RE: Farm Ponds Area Groundwater Remedial Action Progress Summary – Year 2018  
Revised – Response to EPA and DEQ Comments

**Re:** **Farm Ponds Area Groundwater Remedial Action Progress Summary – Year 2018 – Revised**

**FIGURE 1**  
**Farm Ponds Area Monitoring Wells**  
*ATI Millersburg Operations, Oregon*

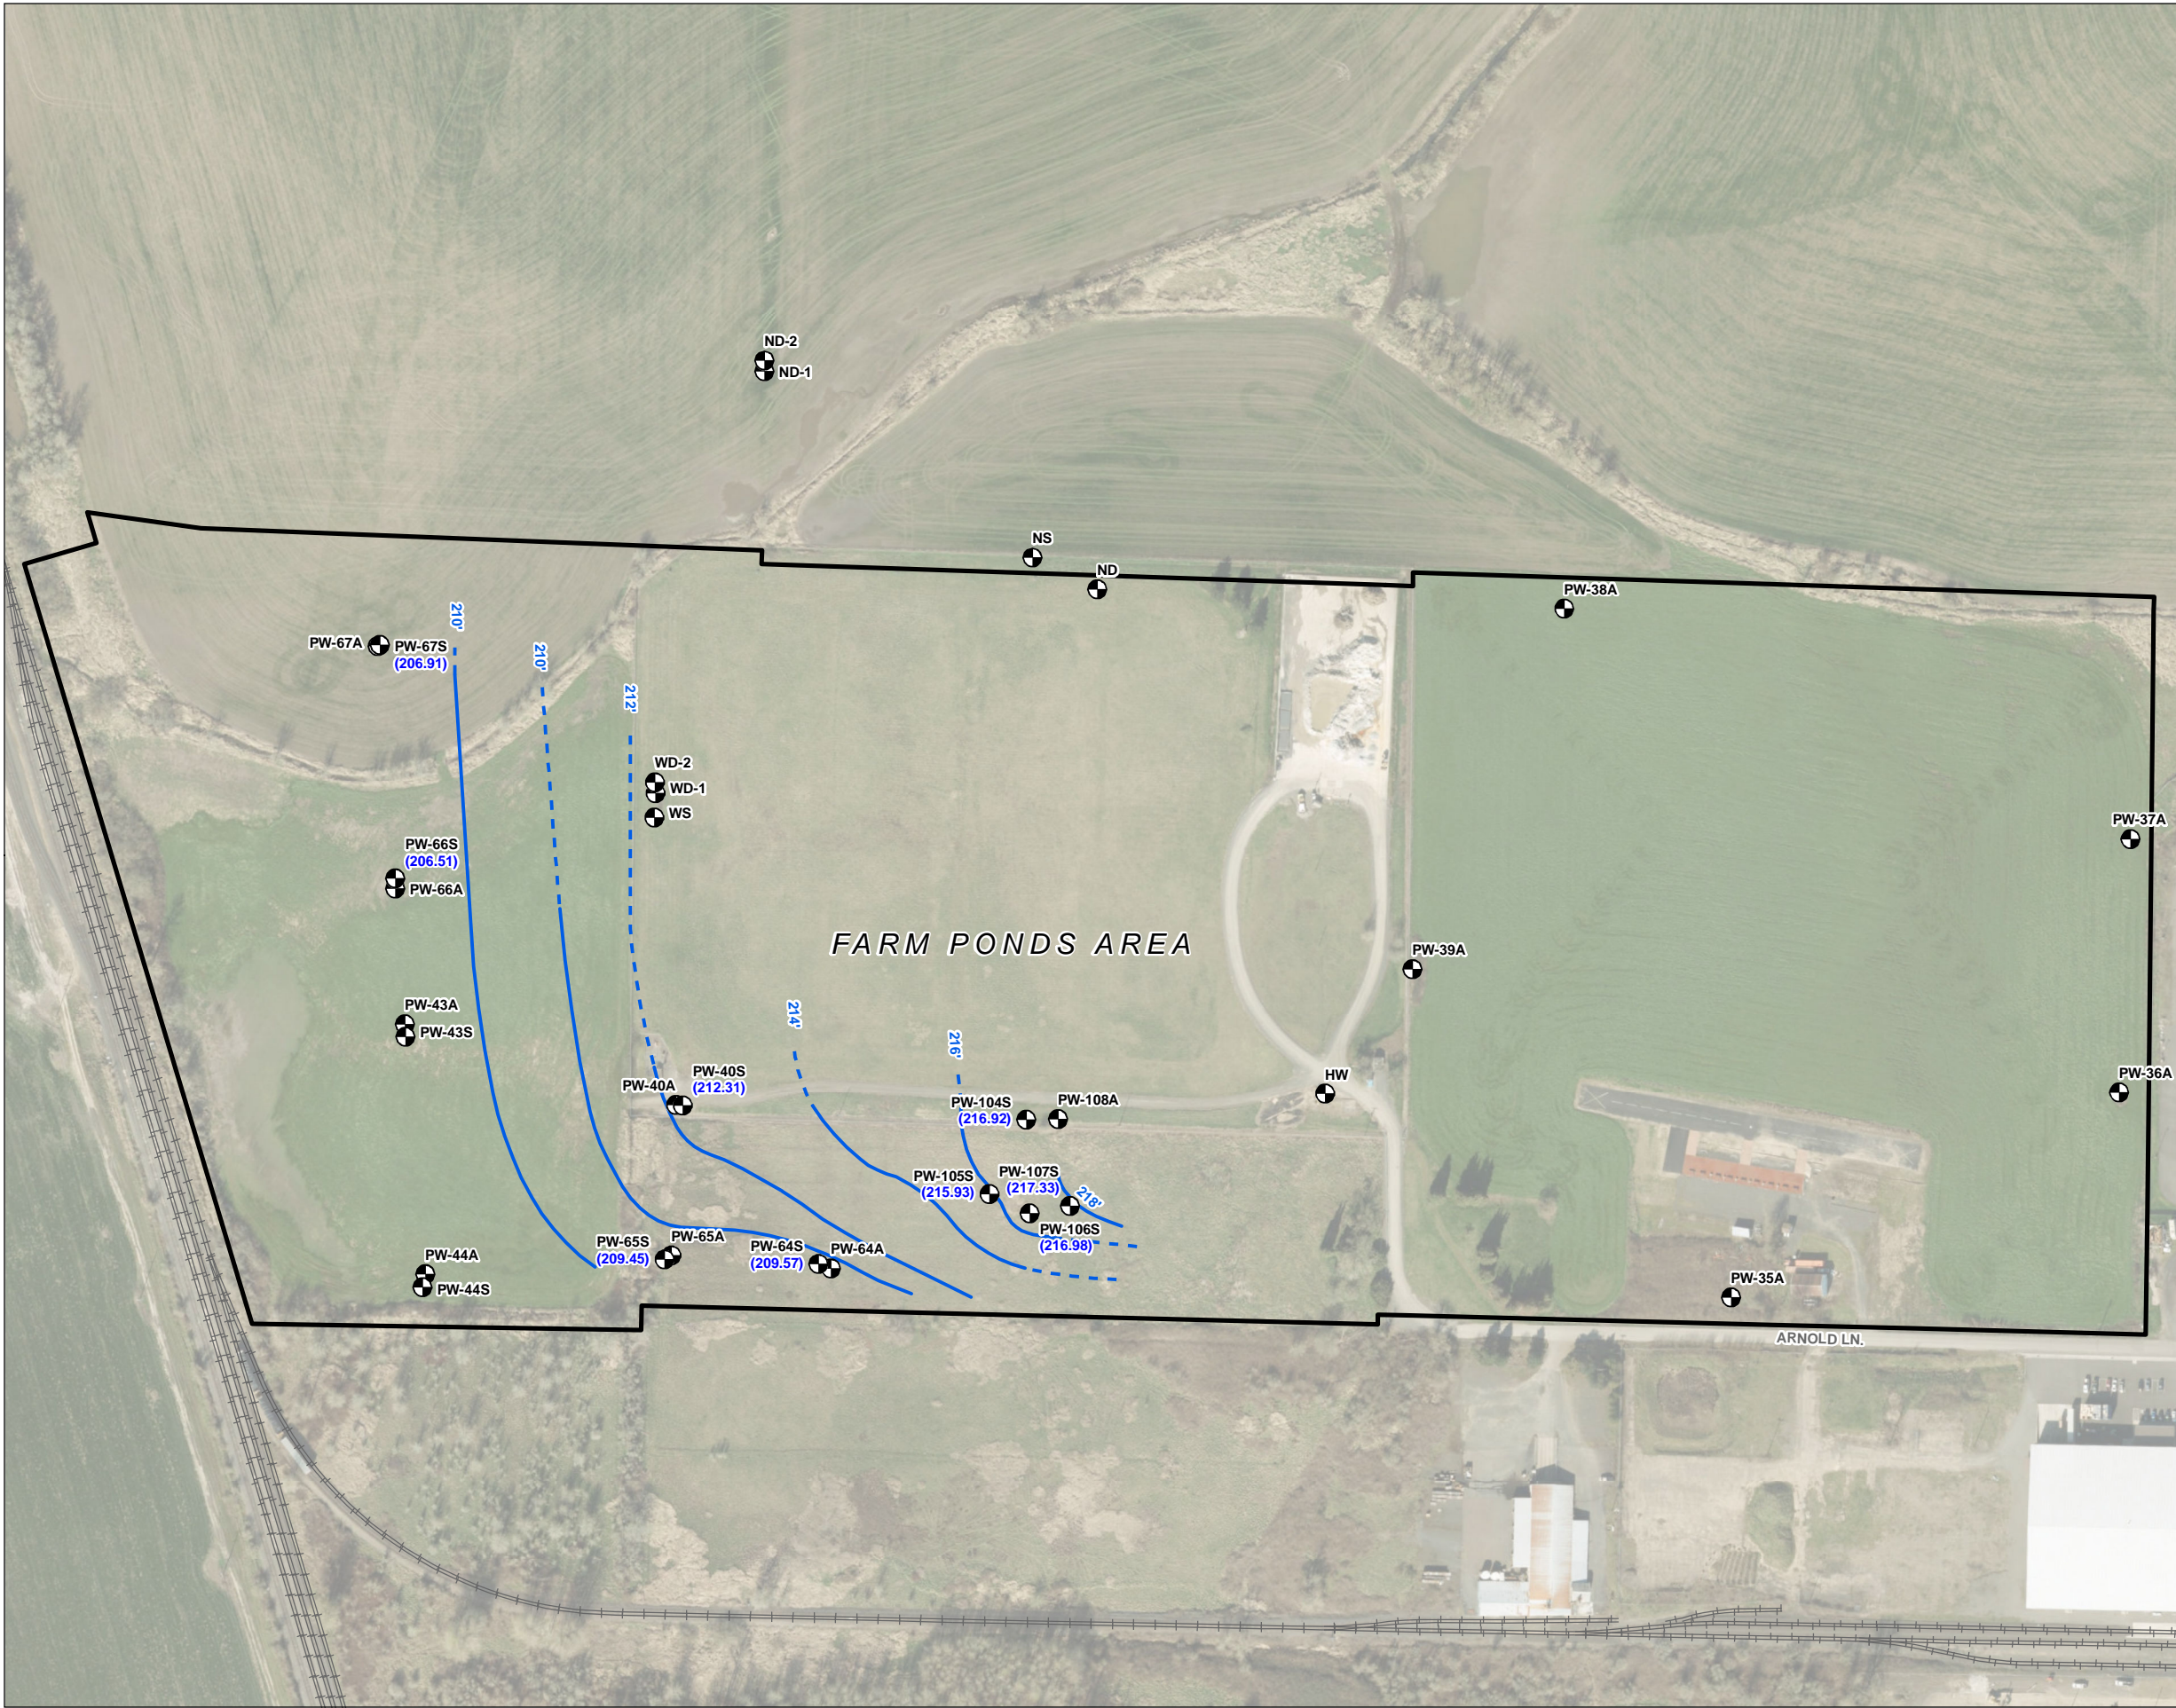
Page 3, Paragraph 1, in referring to well PW-104S located near the former well SS, states: "...ATI installed three permanent downgradient monitoring wells in 2015: PW-105S to the southeast, PW-106S to the south, and PW-107S to the southwest." Based on the well locations shown on Figure 2, wells PW-105S and PW-107S are located southwest and southeast of well PW-104, respectively. This inconsistency needs to be corrected throughout the document. Showing the location of abandoned wells SS and SD on the figure would also help visualize the placement of new well in relation to them and will help with review of historical data.

The cardinal directions have been corrected for PW-105S and PW-107S. Locations of wells SS and SD have been added to Figure 1 for reference.

**FIGURE 2A**  
**Willamette Silt Groundwater  
Contours 2018 Monitoring Event**  
*ATI Millersburg Operations, Oregon*

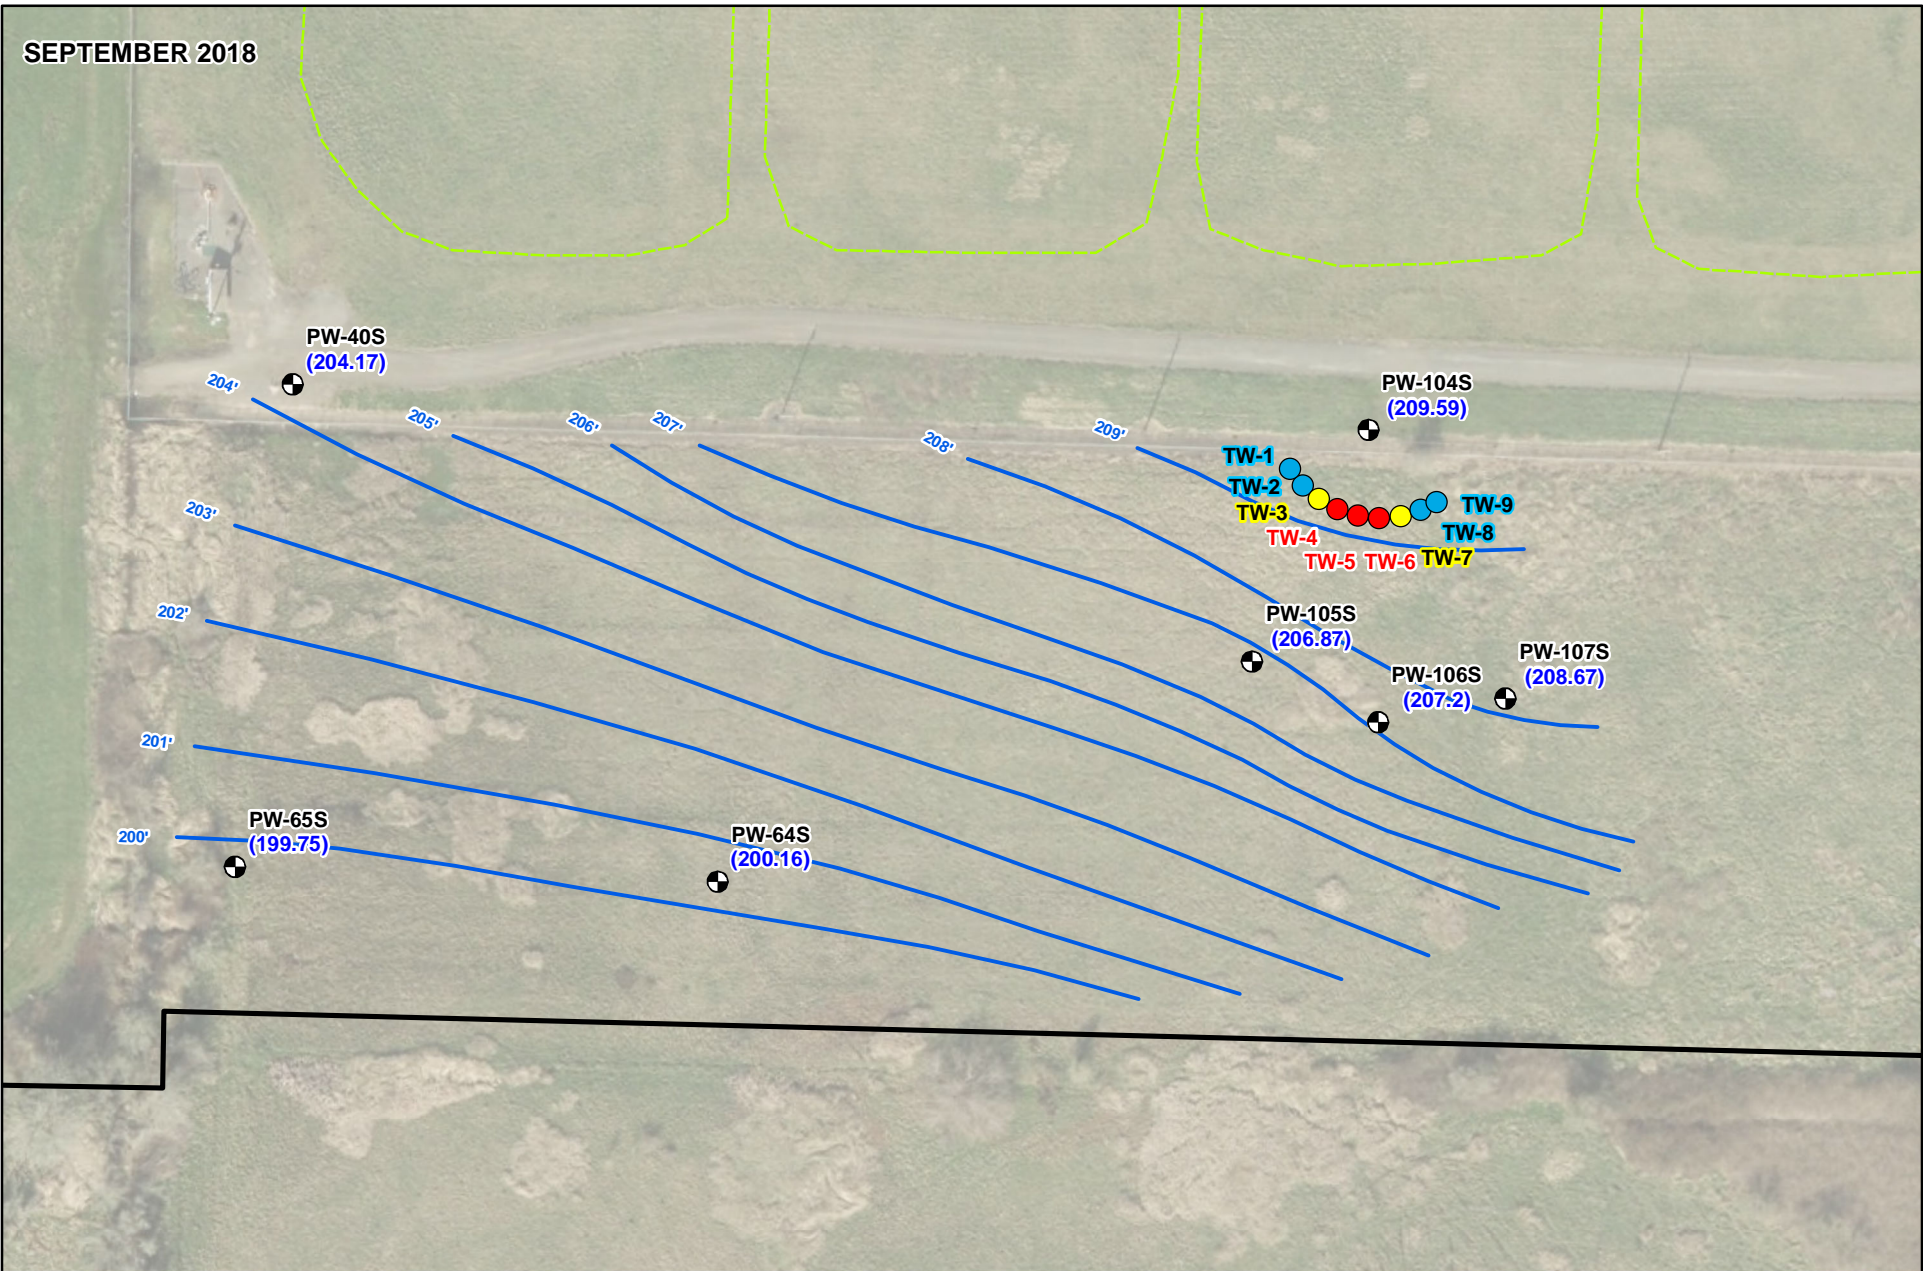
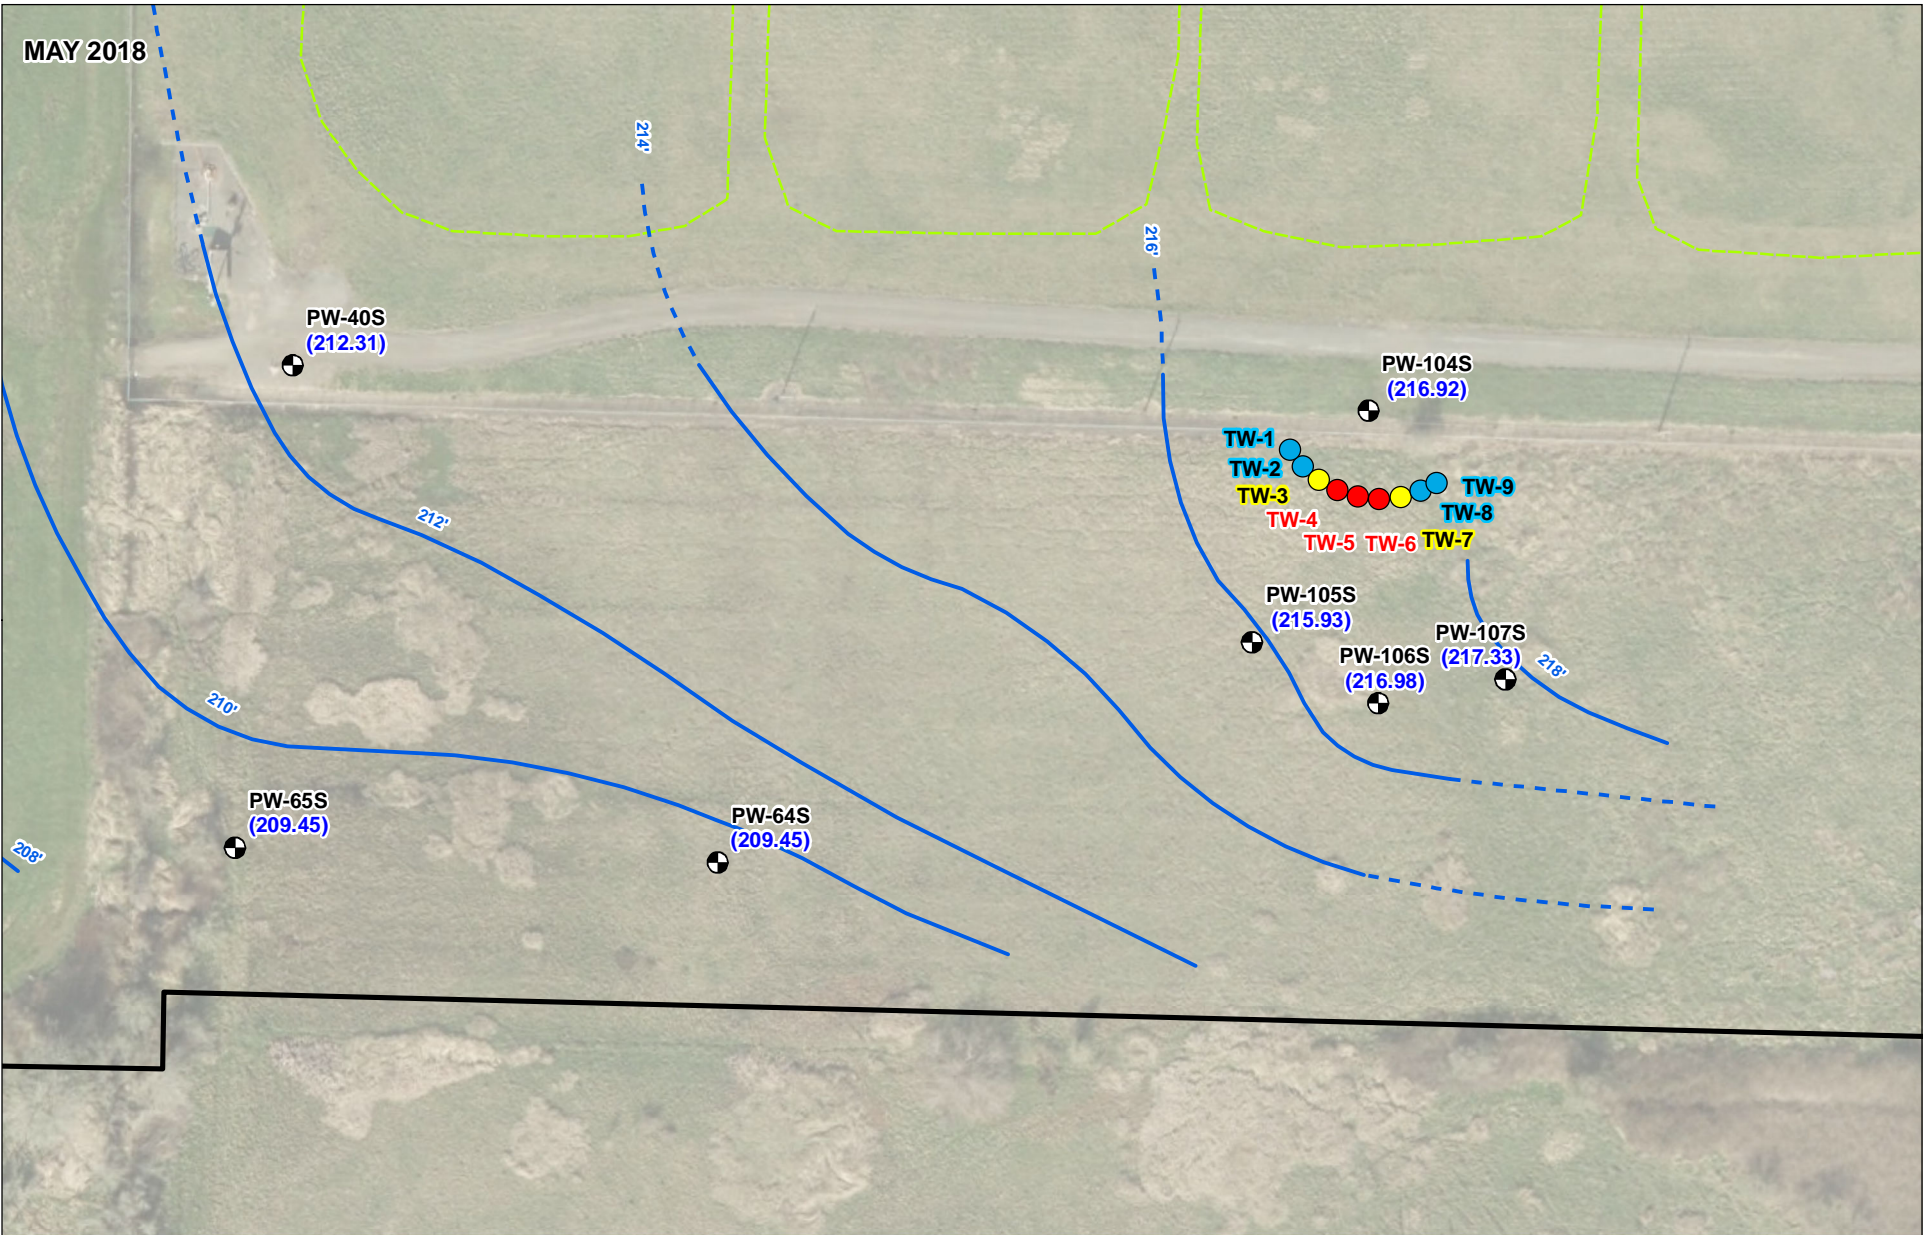
Figure 2 needs to be retitled to clearly indicate it is showing the groundwater contours for the Willamette Silt Unit.

Figure 2 has been updated.

**FIGURE 2B**  
**Farm Ponds Area Groundwater Contours**  
*ATI Millersburg Operations, Oregon*

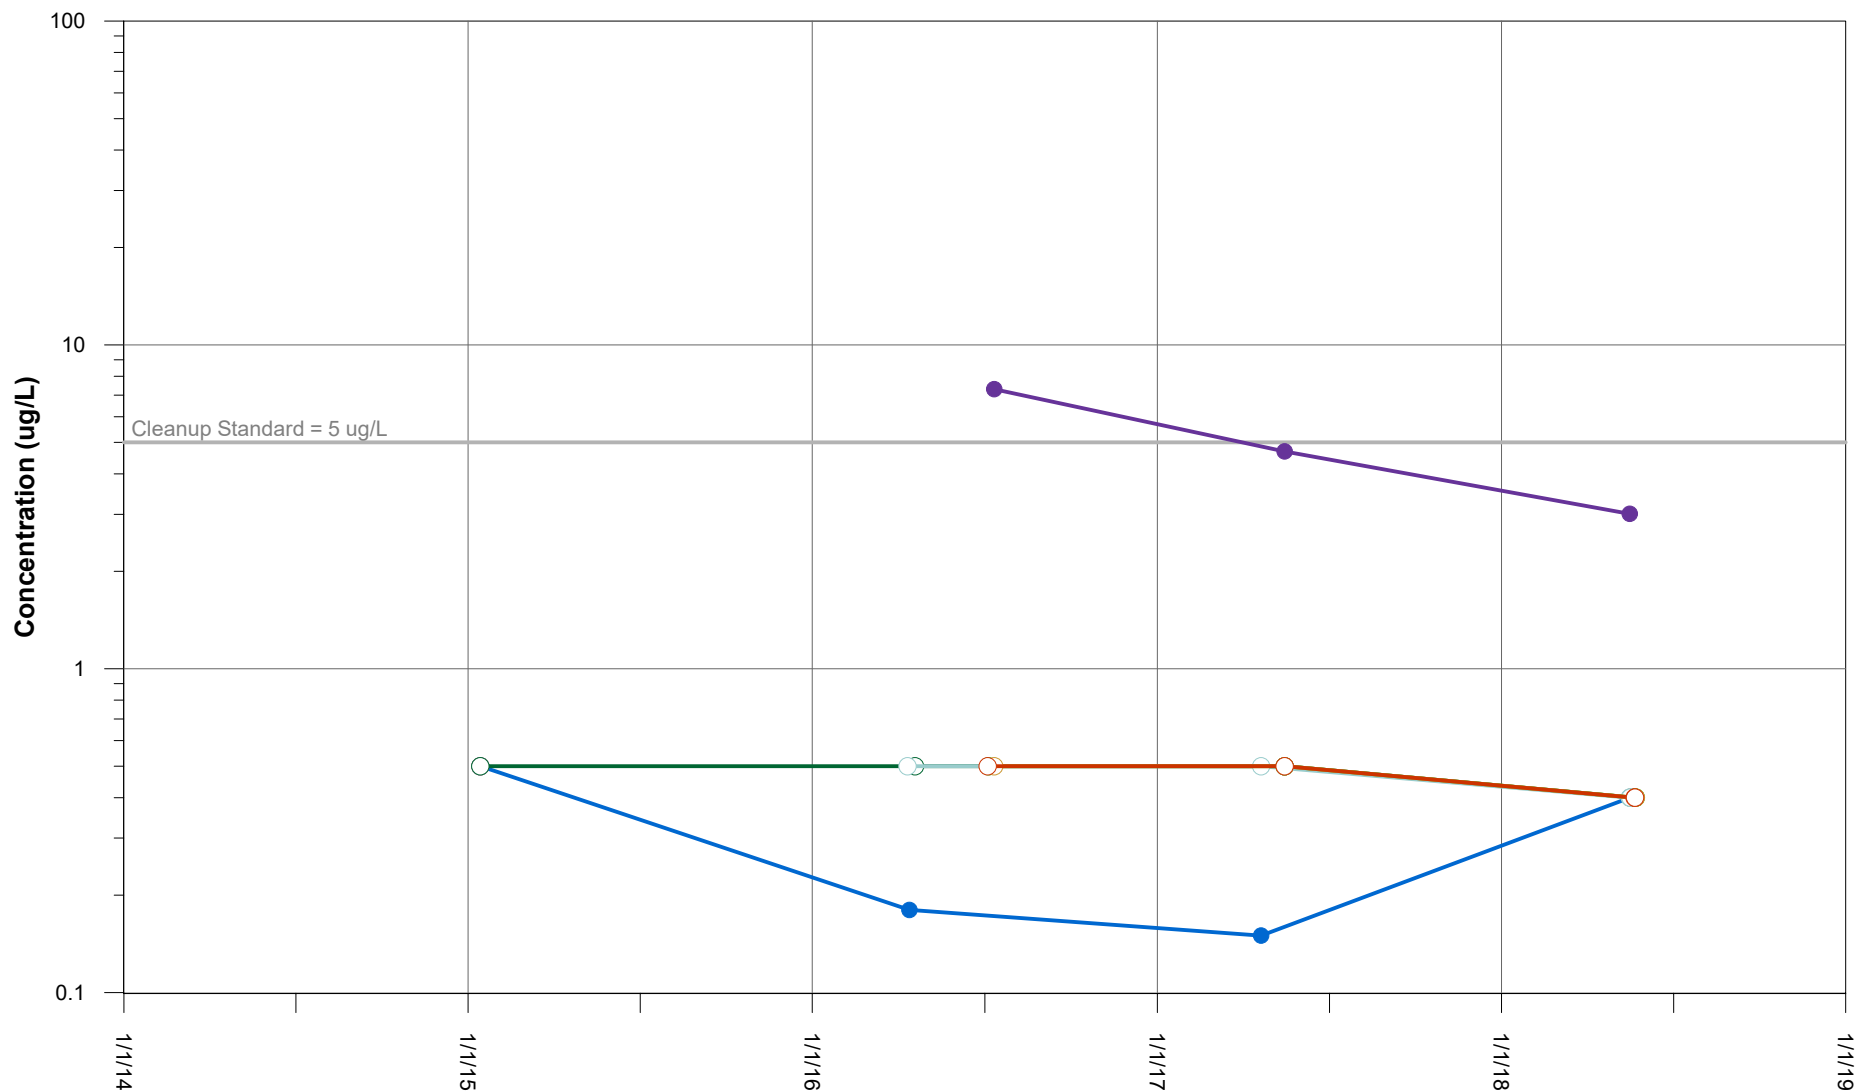
Based on a review of well screen elevations for the seven wells from which groundwater samples were collected for analysis, it appears that five of the well screens have been completed in the lower part of the Willamette Silt. The well screen for Well PW-40s appears to straddle the upper and lower Silt, and the well screen for well PW-108A is completed in the Linn Gravel. Considering that the groundwater flow rates and contaminant transport characteristics will vary between the Upper Willamette Silt, Lower Willamette Silt and the Linn Gravel, provide a complete and representative analysis of groundwater elevations, flow directions, contaminant transport and seasonal variability in the area surrounding PW-104S to support the assessment that nearby wells are properly placed and that the data generated from these wells can support the evaluation of the presence/absence of a contaminant plume.

ATI developed a new figure (Figure 2B) and added discussion of hydrogeology near PW-104S in Section 5 to further support the assessment that CVOCs are localized and not migrating in groundwater.
